**BEFORE THE PUBLIC UTILITY COMMISSION  
OF OREGON**

LC 84

2023 Integrated Resource Plan.

ORDER

Figure 1: Comparison of Portfolio Costs (in thousands)

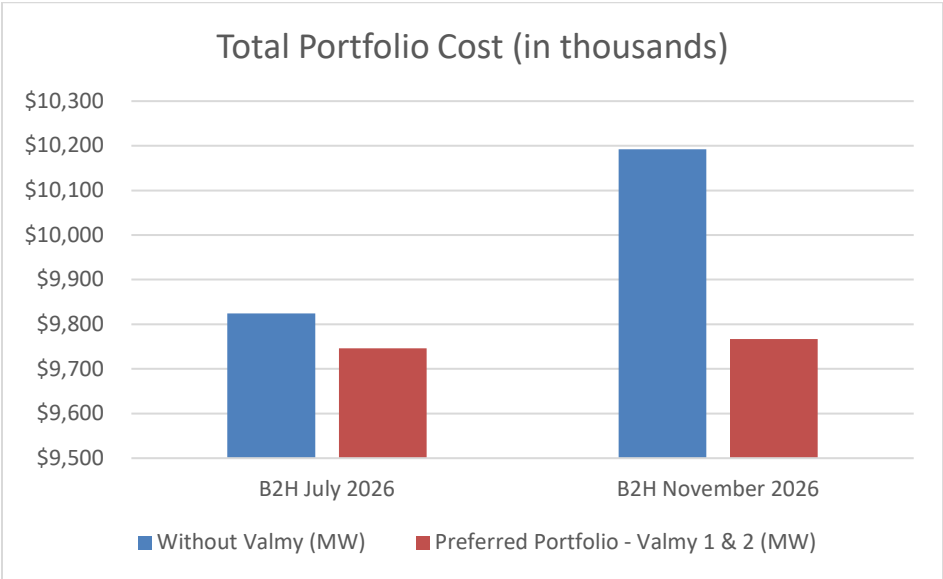
Figure 1 shows the comparison of portfolio costs for the "With Valmy 1 and 2" and "Without Valmy" for both the B2H online in July 2026 and B2H online in November 2026. Allowing the model to select the Valmy conversions provides more than five times the savings in the delayed B2H in-service date of November 2026, as compared to the originally planned B2H in-service date in July 2026. The Company claims that the high savings in portfolio cost of \$425M is a reflection of how Idaho Power's relies on the Valmy conversions to help mitigate the risk of an anticipated delayed B2H in-service date beyond July 2026.<sup>19</sup>

Figure 4: Composition of System Company Electricity Sales (thousands of MWh)<sup>46</sup>

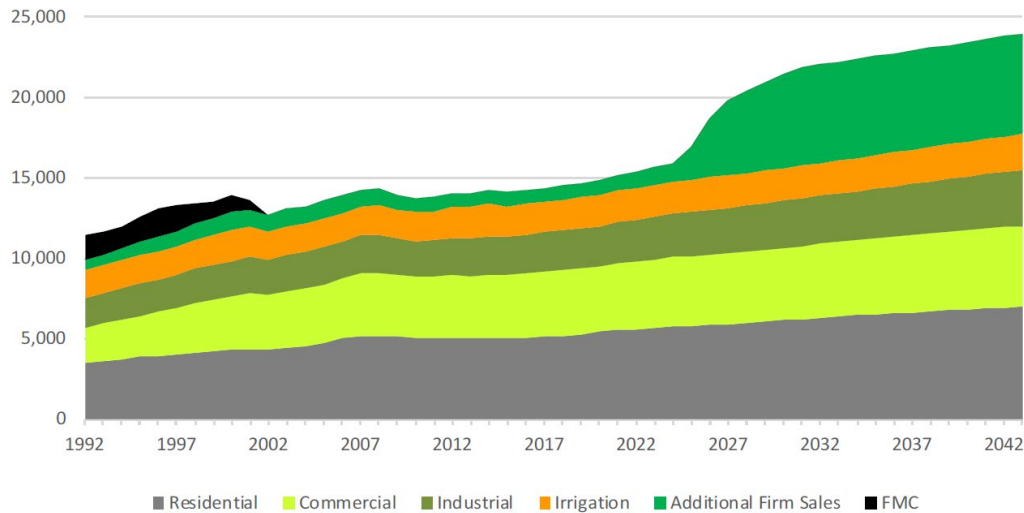
However, the near-term annual average load growth between 2024 and 2028 is especially steep at 5.5 percent and is heavily weighted by additional firm sales to ESA customers, as shown in Figure 4.<sup>45</sup>

Figure 5: IRP Representation of ESA Customer Energy Load in MWh

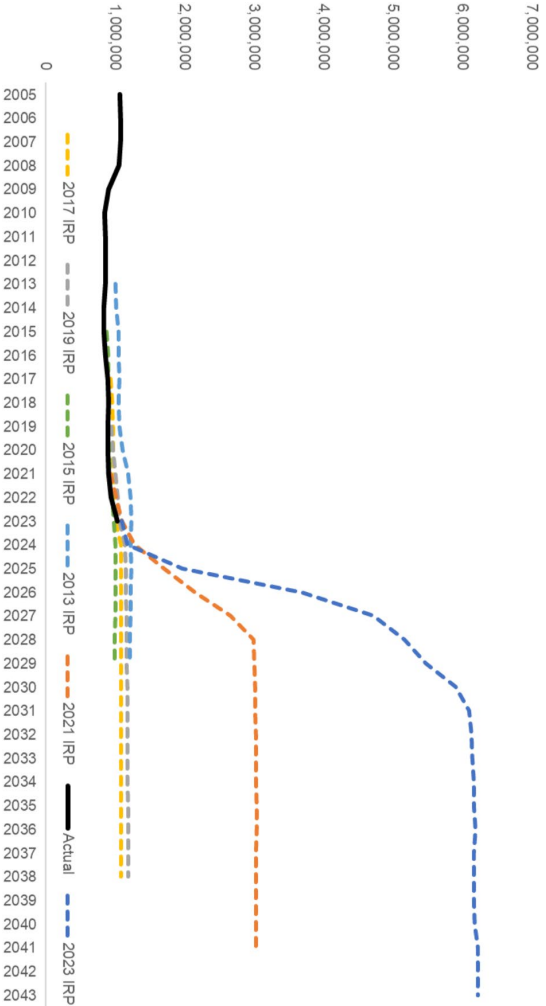
In Comments, Staff noted that the accuracy of Idaho Power's forecast of system load may become compromised if the near-term growth of ESA load does not materialize. Idaho Power is ultimately responsible for the reasonableness of these ESA customers' load forecast and should be prepared to provide oversight to avoid the over-procurement of resources. Figure 5 shows the difference in ESA customer load forecasts across IPC's past IRPs.

Staff agrees that the Idaho Power system is experiencing growth and is supportive of the Company taking the necessary steps to meet these needs. However, Staff notes that this new growth introduces uncertainty regarding timing and volume of need. Given that the Company is currently developing its 2028 RFP (Docket No. UM 2317), Staff plans to address this issue in the RFP design and associated sensitivities.
